SI B11 23 14
Engine

SB-10057339-1116

Service Action: Replace the Thermostat (F10)

F10 (5 Series Sedan)

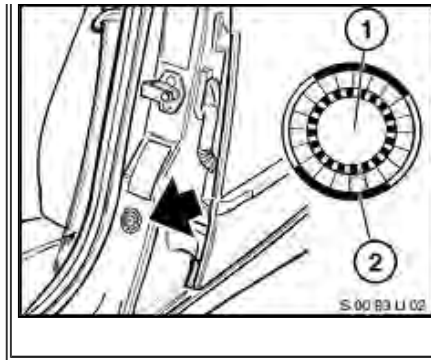
- A. Emboss your BMW center warranty number in the middle of the label (1);
- B. Punch out code number **720** (2), printed on the label; and
- C. Affix the label to the B-pillar as shown.
